## **Response to Comments**

### **Swift Creek Action Plan, Consent Decree, and Public Participation Plan**

#### **Swift Creek Project Everson, WA**

December 2019

Swift Creek - EXHIBIT A

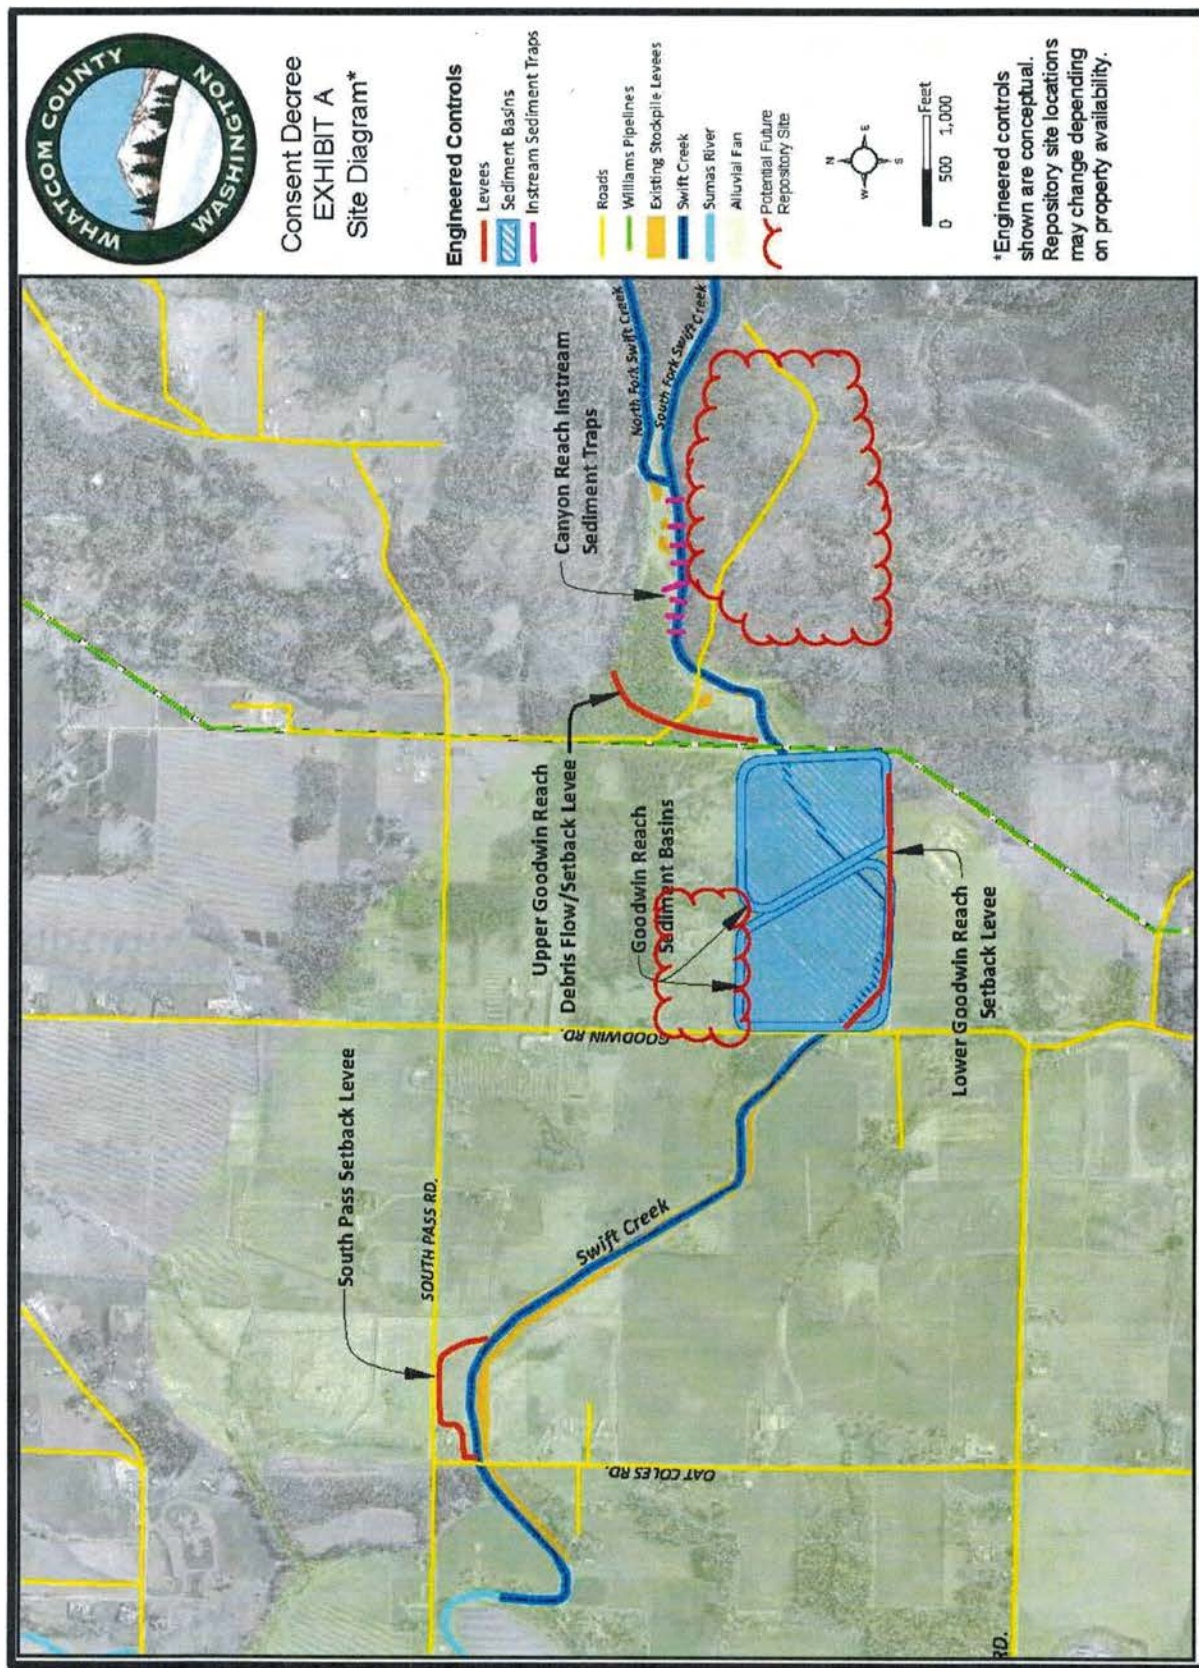
Please refer to the attached Consent Decree EXHIBIT A Site Diagram, and to the attached text explanation entitled Swift Creek Action Plan engineered controls diagram.
